**Manor Road.  
Richmond.**  
**Avanton Richmond  
Development Ltd.**

**ENERGY STRATEGY**  
RESPONSE TO GLA COMMENTS

REVISION 02 – 16 MAY 2019

## Appendix B – PV array sizing

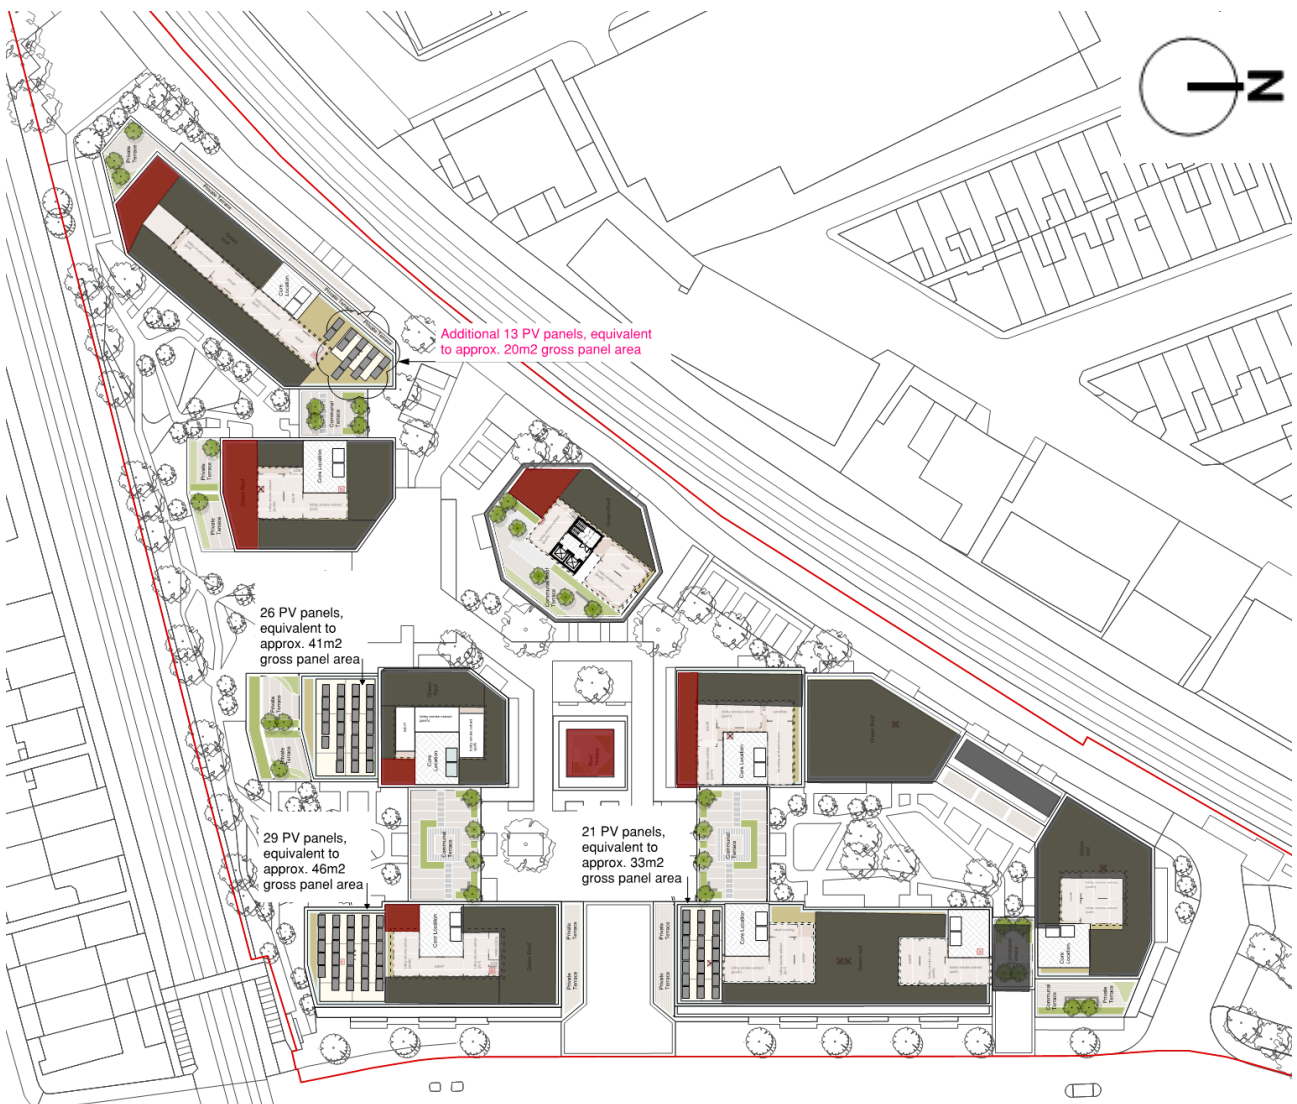
29. PV is being proposed equating to circa 120 m<sup>2</sup> of net PV area; the applicant should confirm the proposed kWp. From the basic roof layout provided, there appears to be additional space for PV. A detailed roof layout should be provided demonstrating that the roof's potential for a PV installation has been maximised and clearly demonstrating any constraints. The applicant is required to maximise the on-site savings from renewable energy technologies, regardless of the London Plan targets having been met, and therefore the PV proposals should be reviewed. It should also be noted that the PV savings reported of 3.3 tonnes of CO<sub>2</sub> /annum are considered very low.

- Point 29: The PV array proposed in the planning application stage energy strategy was equivalent to an estimated 18kWp. This was based on an appraisal of available, accessible and unshaded roof area. The applicant has undertaken a further review of the roof areas based on the latest design information, and one further location suitable for a PV array has been identified. This location is expected to be able to accommodate 13 further panels, equivalent to approx. **20 m<sup>2</sup>** of PV panel area, and equivalent to an additional **4kWp (i.e. now a total of 22kWp)**. This is estimated to result in **0.6 tCO<sub>2</sub>** additional carbon emission reductions (i.e. now a total estimated carbon emission reduction of **3.9 tCO<sub>2</sub>/year** from PV). The roof mark-up which was provided within the energy strategy has been updated to confirm where roofs are expected to be overshadowed, and where roof areas are expected to be of insufficient size to accommodate an array of PVs. Please refer to Appendix B. PV panels have been spaced apart to ensure overshadowing will be minimised from surrounding elements such as parapets, and from adjacent rows of PVs, and to allow access for maintenance. The spacing has been based on good-practice guidance – please refer to Appendix B for further details.

The roof layout has been detailed further since the planning application, and plant allocations have changed slightly. This has allowed for a further PV array on the affordable block to the SW of the site. Please see an updated roof layout below. We have now marked this up further to annotate areas that are likely to be overshaded, and areas that are estimated to be too small for individual PV arrays. In total, an additional ~20m<sup>2</sup> of PV panel area (13 panels) has been allocated, resulting in an expected further 0.6 tonnes carbon emission reductions for the site.

## Appendix C – ASHP selection - technical datasheet (Mitsubishi)

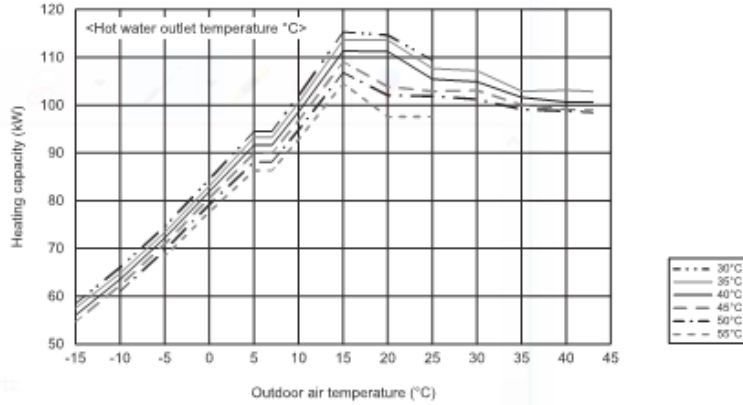
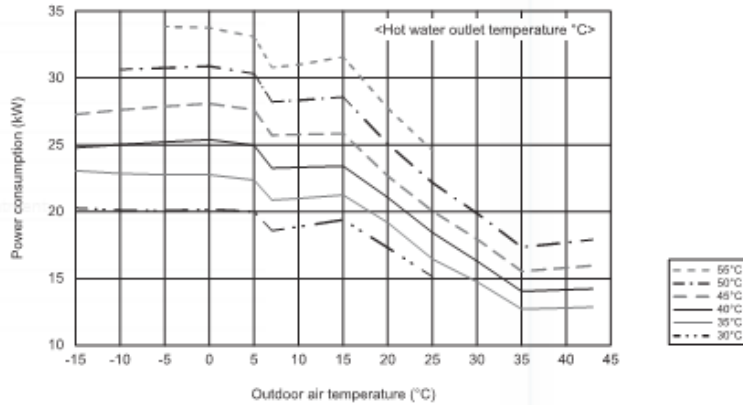
- c. Manufacturer datasheets showing performance under test conditions for the specific source and sink temperatures of the proposed development and assumptions for hours spent under changing source temperatures. Whether any additional technology is required for hot water top up and how this has been incorporated into the energy modelling assumptions.
- d. The expected heat source temperature and the heat distribution system temperature with an explanation of how the difference will be minimised to ensure the system runs efficiently.
- e. A commitment to monitor the performance of the heat pump system post-construction to ensure it is achieving the expected performance approved during planning. (It is recommended that boroughs condition this).

- b. The SCOP for the heat pumps proposed is 2.89. This is based upon data provided by the manufacturer, showing the heat output and power input at a range of conditions (please refer to appendix C). The manufacturer has confirmed the SCOP calculation is based upon the following breakdown of runtime at each condition:

- 5% at -5°C
    - 40% at 3°C
    - 45% at 9°C
    - 10% at 15°C
  - c. The direct electric element has been included in the energy modelling in the form of a compound COP, which accounts for the proportion of top-up from the immersion heater, with a COP of 1. Please refer to page 11 of the energy strategy submitted in support of the planning application for further details.
